PROJECT DESCRIPTION

The proposed development includes construction of a four story apartment building with 28 units and 23 parking spaces. Some parking would be located in structured parking accessed from 14th Ave W, and some parking would be surface parking accessed from the alley.

DESIGN DEVELOPMENT

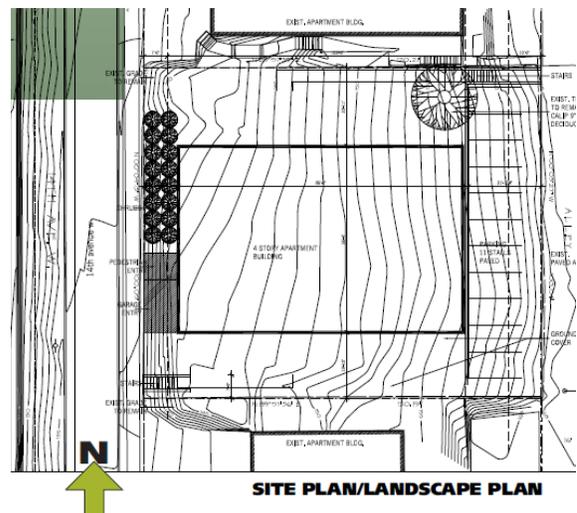
The first scheme and applicant-preferred scheme (Design Concept A) showed a wider building with more street frontage, located closer to the front property line. The massing allowed a larger open space at the east side of the building, with surface parking located close to the east property line. A 150 square foot rooftop deck was shown on the north portion of the building. The pedestrian entry was shown at the north side of the 14th Ave W street front, with the garage entry shown at the south side of this street front. Beneficial aspects of this

option include a defined street wall, large potential for views to the west for residents of this building, the larger building mass is located to the west to allow views across the site from above, the roof deck would be located to maximize views, and large open space on the east side of the site. Cons included a lack of views for rear-facing residents and a structure

closer to the side property lines.

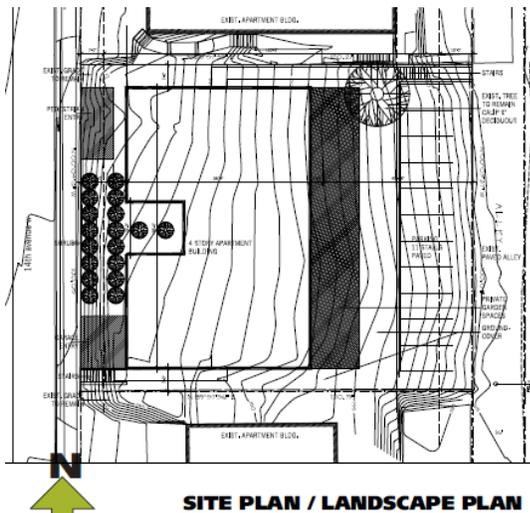
The second scheme (Design Concept B) showed a structure with narrower street frontage that extended further toward the east property line. The pedestrian and garage entries were shown combined near the south end of the 14th Ave W street frontage. Beneficial aspects of this option include a greater light and air for adjacent neighbors to the north and south, and more views through the site on either side of the building. Cons included more units facing north and south with impacts to existing neighbors' privacy, limited views for proposed residences to the west, less opportunity for

combined open space areas on site, potential for blank walls on the west façade, and larger excavation impacts to the slope.
